# V<sub>On\_PD</sub> & V<sub>Off\_PD</sub> v100

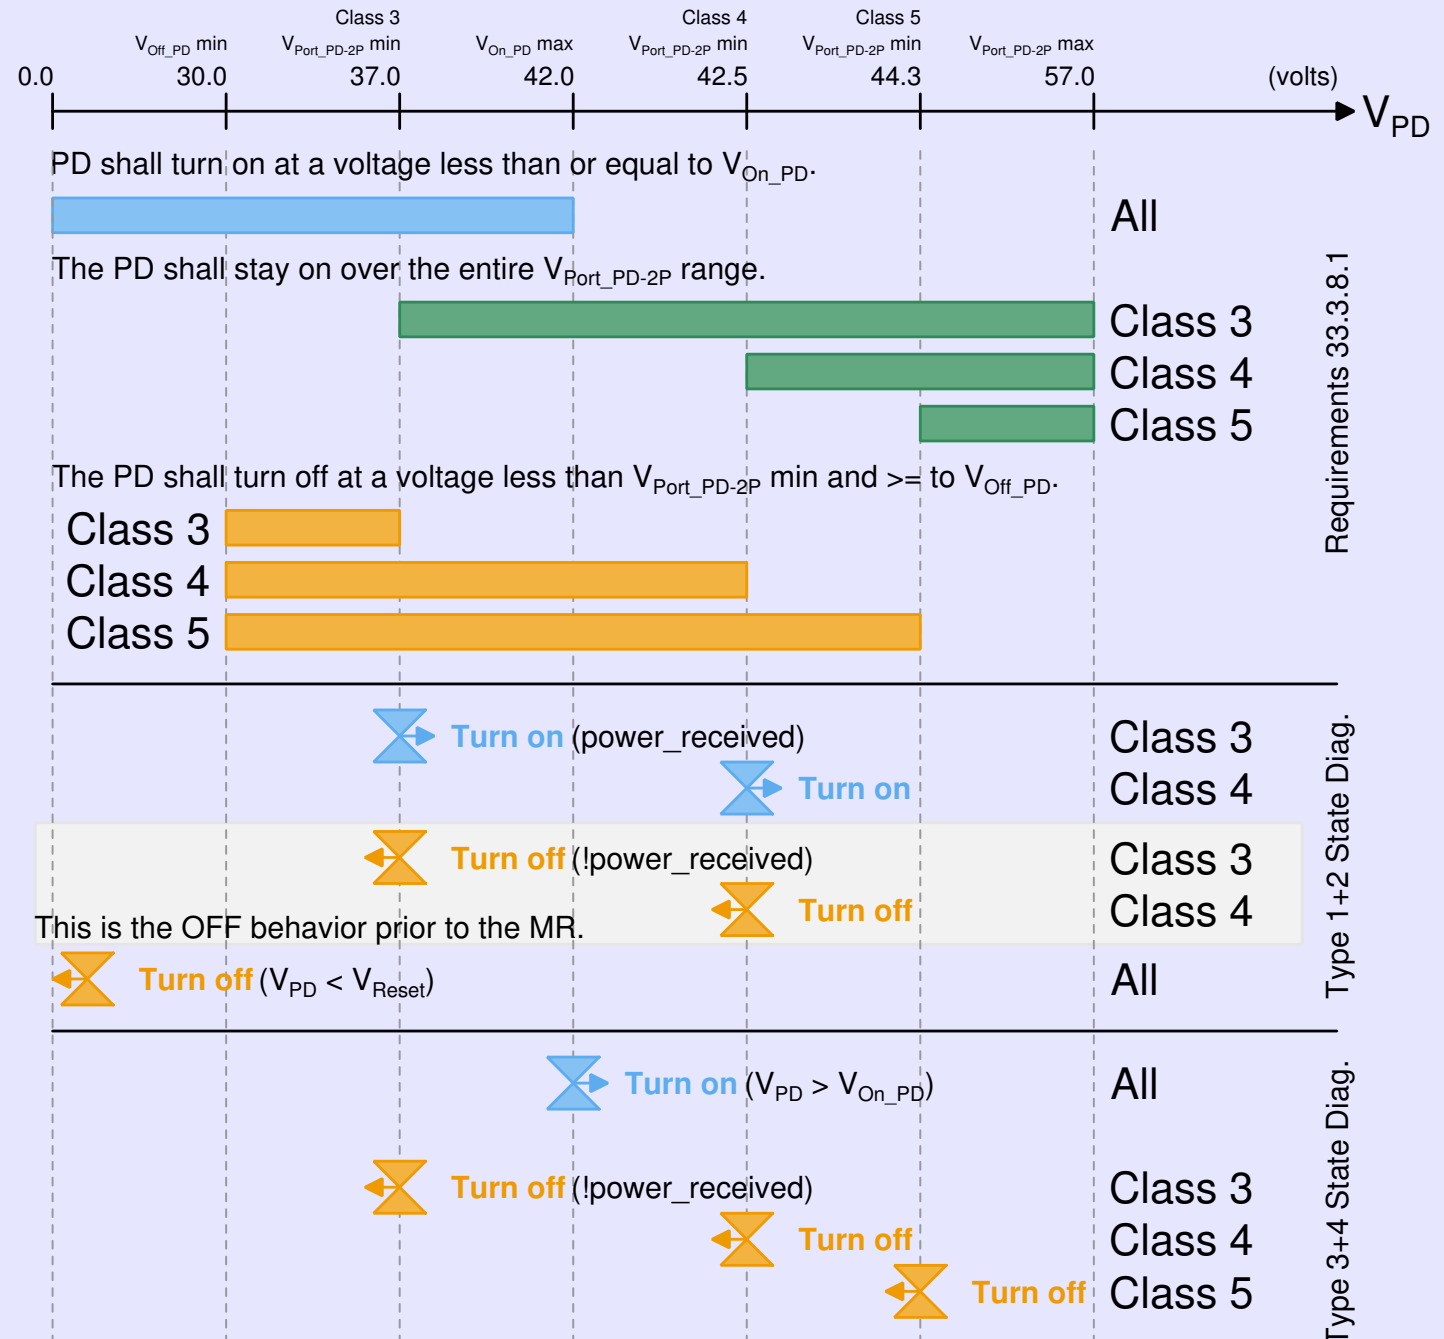
V<sub>On\_PD</sub> is currently defined as “PD Power supply turn on voltage”, it only has a maximum value: V<sub>On\_PD</sub> max = 42V  
 V<sub>Off\_PD</sub> is currently defined as “PD power supply turn off voltage”, it only has a minimum value: V<sub>Off\_PD</sub> min = 30V  
 There are three requirements in the text:

- The PD shall turn on at a voltage less than or equal to V<sub>On\_PD</sub>.
- After the PD turns on, the PD shall stay on over the entire V<sub>Port\_PD-2P</sub> range.
- The PD shall turn off at a voltage less than V<sub>Port\_PD-2P</sub> min and greater than or equal to V<sub>Off\_PD</sub>.

- The text requirements do not match with the Type 1/2 PD state diagram.
- The text requirements do not match with the Type 3/4 PD state diagram.
- The text allows the PD to turn on at any voltage lower than 42.0V, which cannot work!

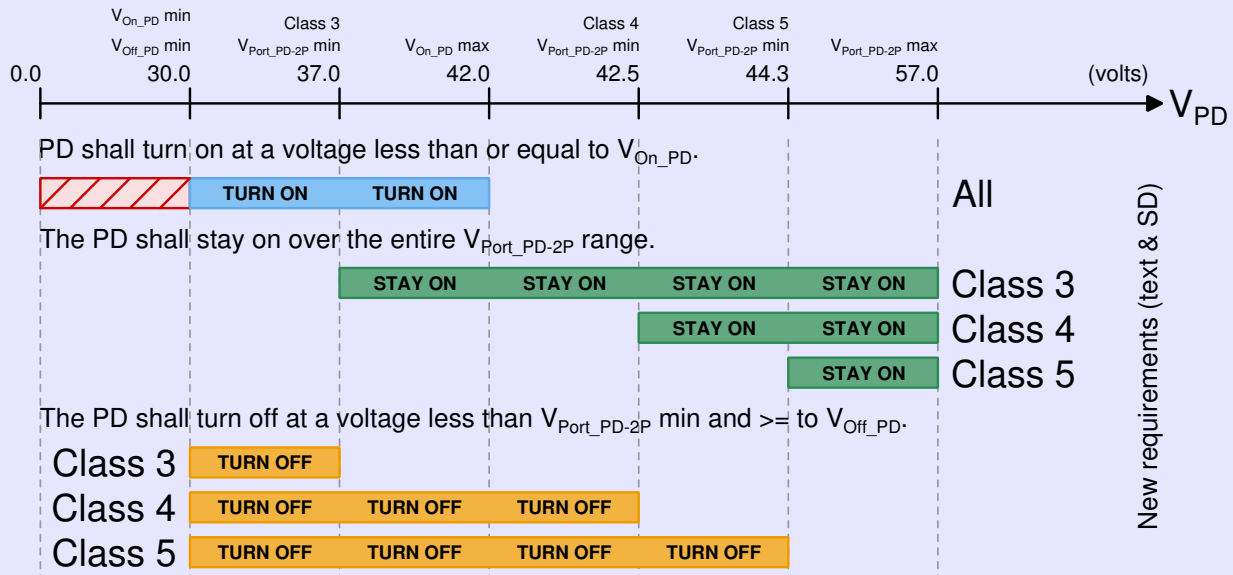
The text is closest to reasonable requirements, with only a modification needed to  $V_{On\_PD}$ : PDs should turn on *above* 30V, not at any voltage lower than 42V. The desired voltage ranges would be:

Item	Parameter	Symbol	Unit	Min	Max	PD Type	Add info.
14	PD power supply turn on voltage	$V_{On\_PD}$	V	30.0	42.0	All	See 33.3.8.1
	PD power supply turn off voltage	$V_{Off\_PD}$		30.0	$V_{Port\_PD-2P\ min}$

The PD shall turn on at a voltage ~~less than or equal to~~ in the range of  $V_{On\_PD}$ . After the PD turns on, the PD shall stay on over the entire  $V_{Port\_PD-2P}$  range. The PD shall turn off at a voltage ~~less than  $V_{Port\_PD-2P\ min}$  and greater than or equal to~~ in the range of  $V_{Off\_PD}$ . For dual-signature PDs the requirements for  $V_{On\_PD}$  and  $V_{Off\_PD}$  apply to each pairset individually.
